Addendum #2

Re: **Addendum No. 2**
Richmond Community College
Hendrick Center for Automotive Training
1042 West Hamlet Avenue
Hamlet, NC 28345
ADW Project Number: #23014

These clarifications constitute Addendum No. 2 and considered part of the Bid Documents. General Contractor shall see that their sub-contractors are in full receipt of the information contained herein.

C200

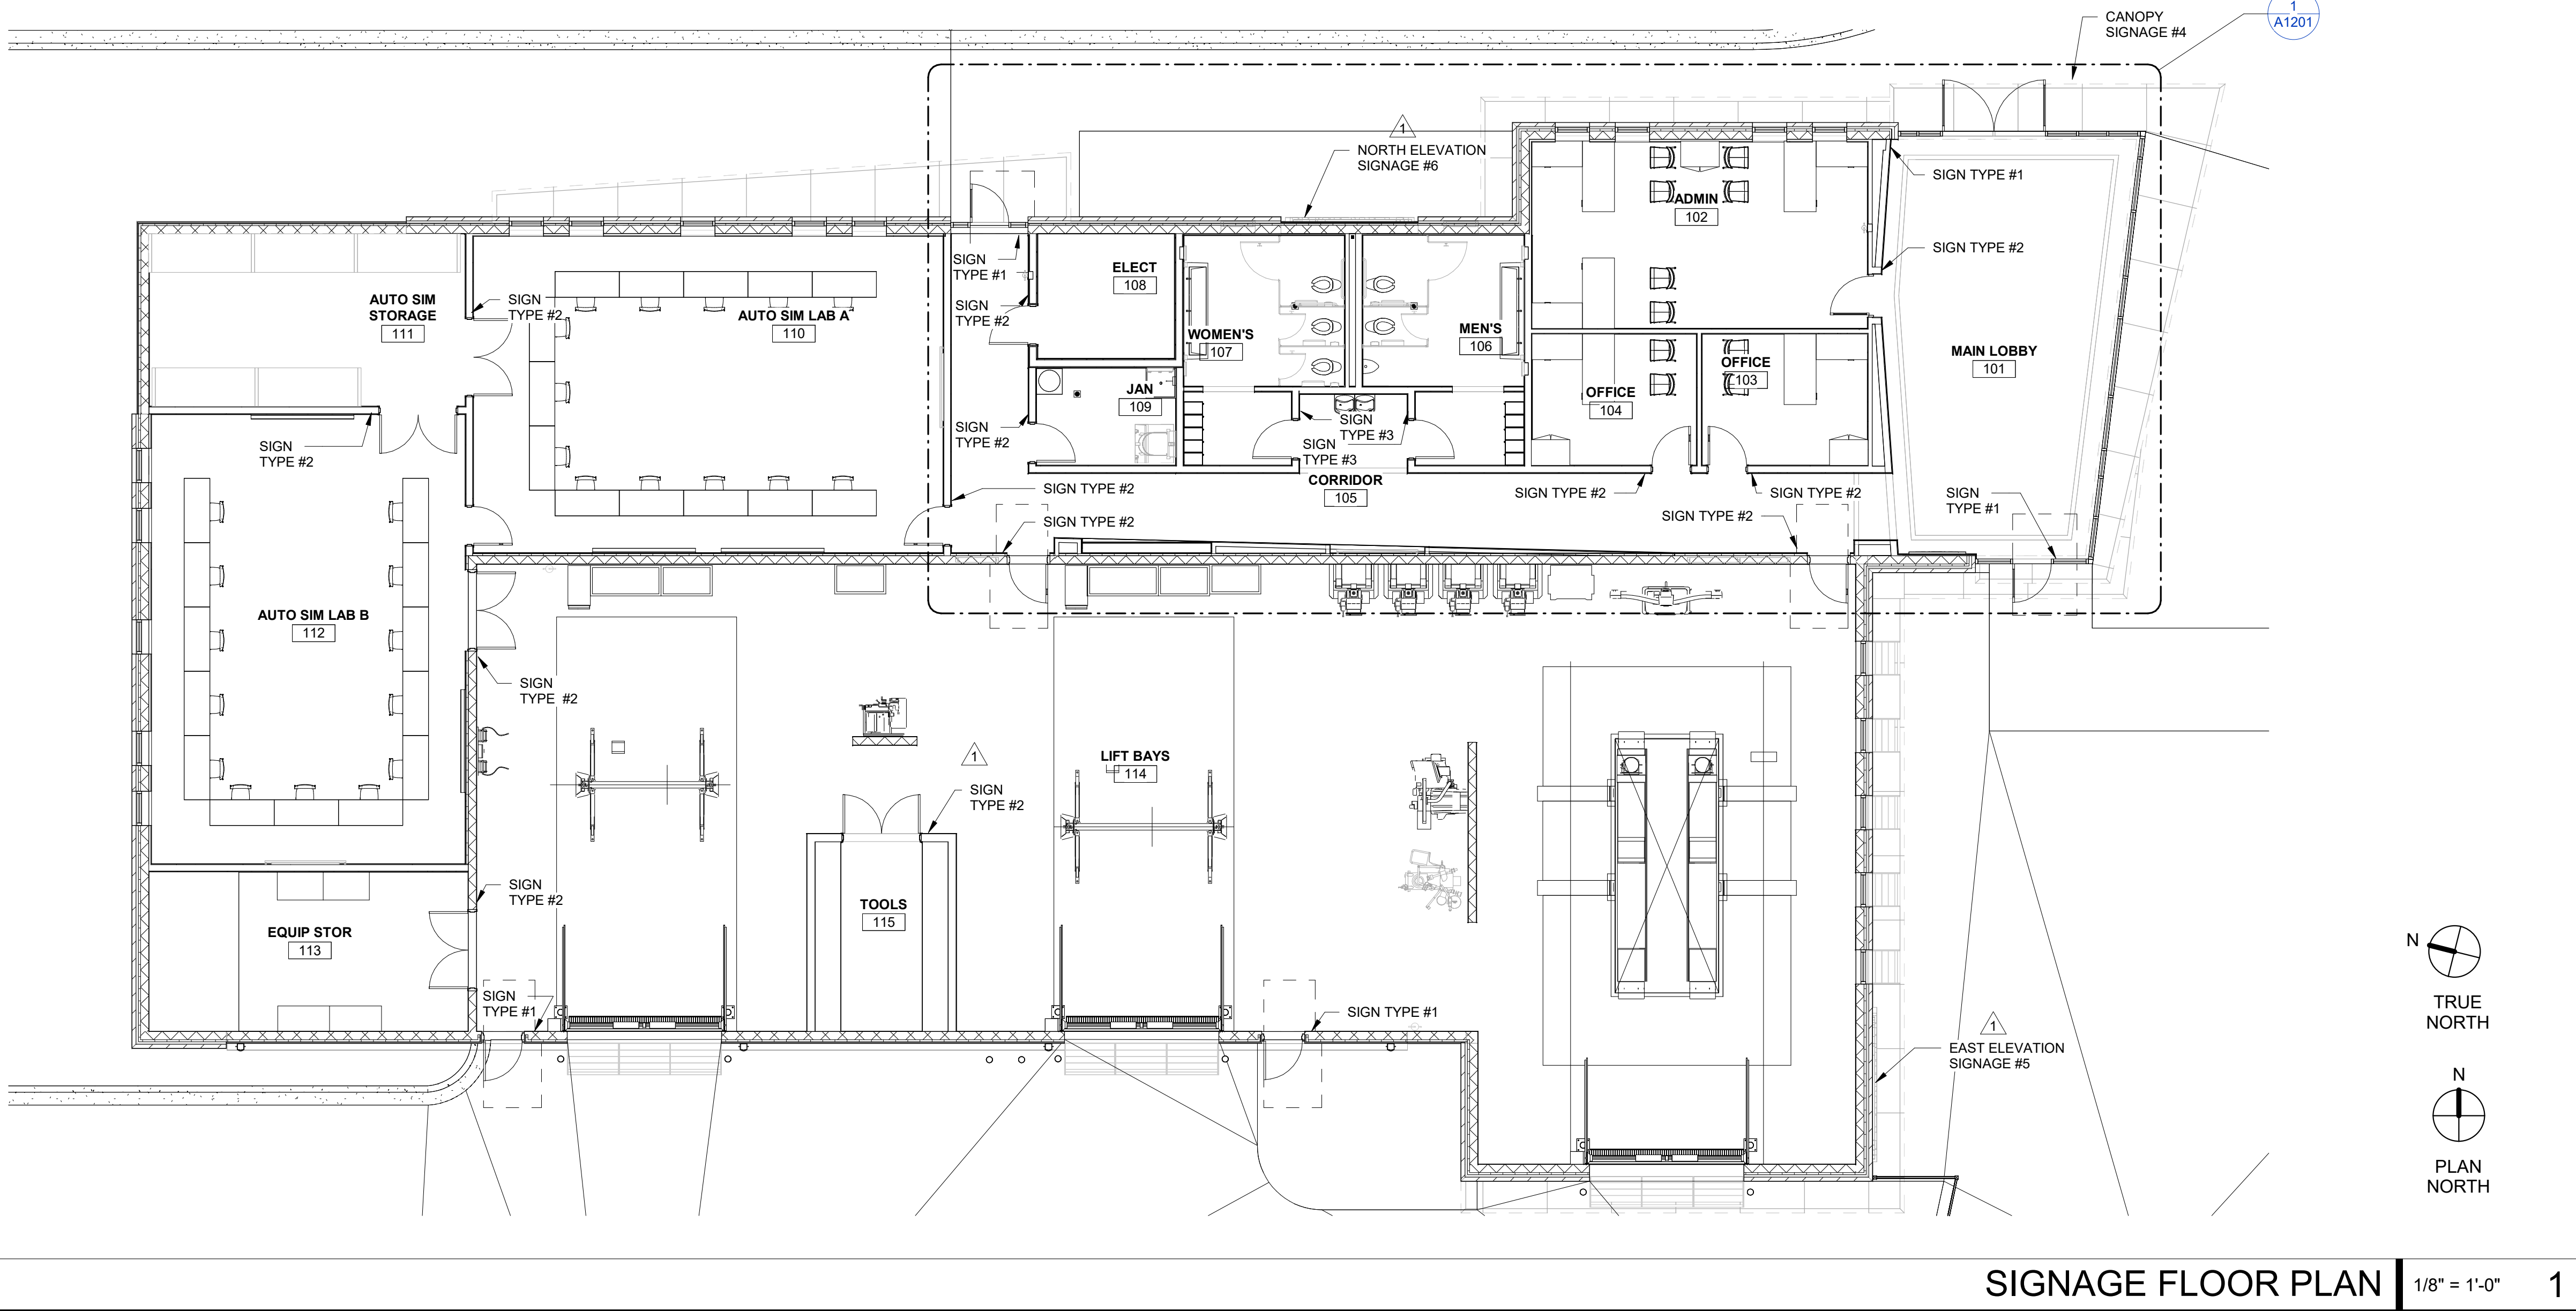
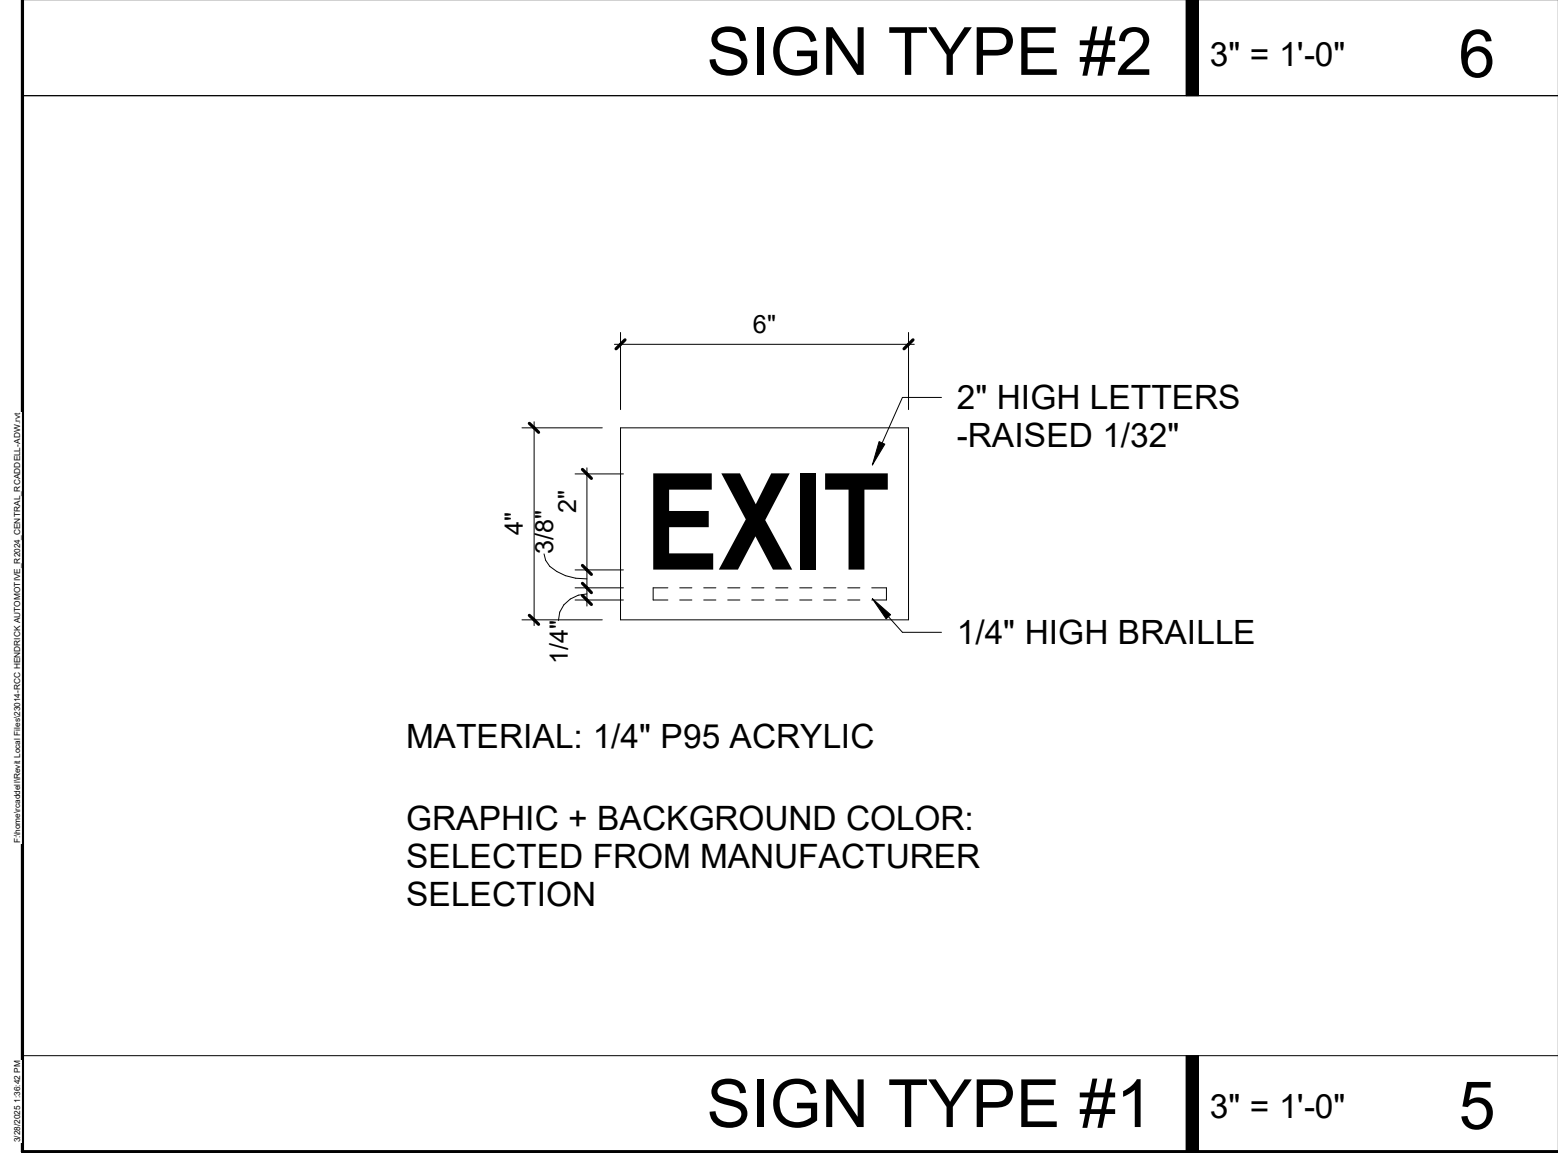
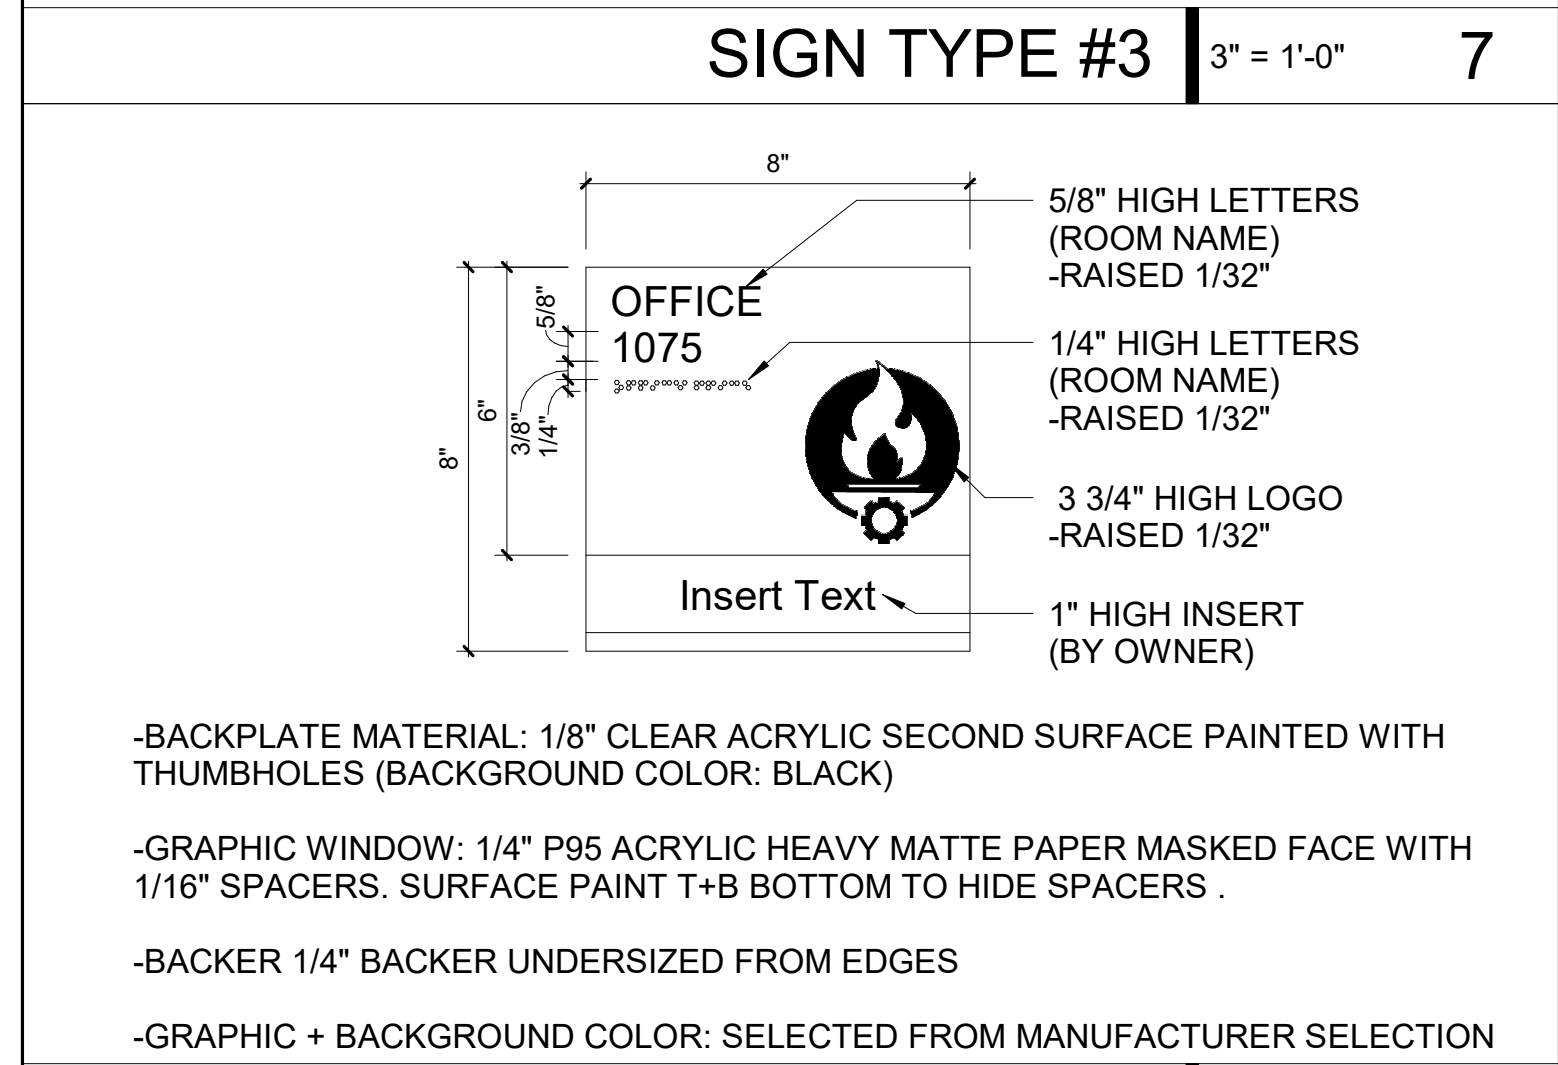
- 1.) A1200
 - a. Details 2 and 3: Delete “PREFINISHED STAINLESS STEEL SIGNAGE” from note.
- 2.) C200
 - a. Revised Sheet C200 to adjust the location of the sanitary sewer to avoid the trees.
- 3.) A600
 - a. Change door material in schedule and door types to Aluminum for overhead doors 114D, 114E and 114G.

- a. Overhead doors should be aluminum with powder coat finish.
- 6) Per review of the civil plan sheet C200. The new sewer line location as shown on the noted above plan sheet will be cutting through the existing tree root ball/root lines for the two existing trees and this will kill these two existing trees. Please review the attached red line plan on this issue and confirm the new sanitary sewer line extension can be relocated to run along the edge of the existing sidewalk. Confirm the location of the existing water lines for the existing water utility locations as shown on this plan to coordinate the new installation of new sewer line.

- a. Revised Sheet C200 to adjust the location of the sanitary sewer to avoid the trees.
- 7) There is a section 32 92 00 – Lawns and Grasses in the Specs Manual, but there is no Landscaping drawing. Do we have to include any landscaping prices?
